In my earlier public comment, I did not capture the previous agreement correctly. It said:

Steve Weiss 210 grove St.

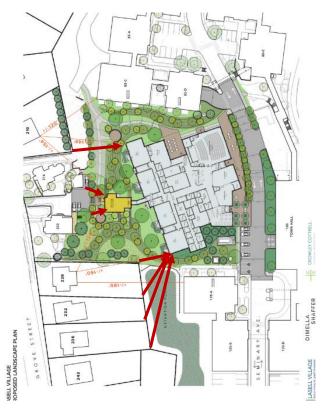
The drawings from Lasell University on the distances of the new buildings are from the abutting houses to the proposed 24 Robin Dell property. With respect to the past agreement, the distances should be measured "**to the nearest exterior lot line of the site**." Meaning the proposed 4 story building is significantly closer than what would have been allowed in the past agreement.

Based on the language of the original agreement, it is obvious that numerous properties along grove street are not 150 ft from the proposed building **as measured from the lot line**. I include the Lasell University properties at 216 and 22 which are correctly considered abutters to the Lasell Village proposed building once the ownership is transferred as will be required as Lasell University and Lasell Village are independent entities.
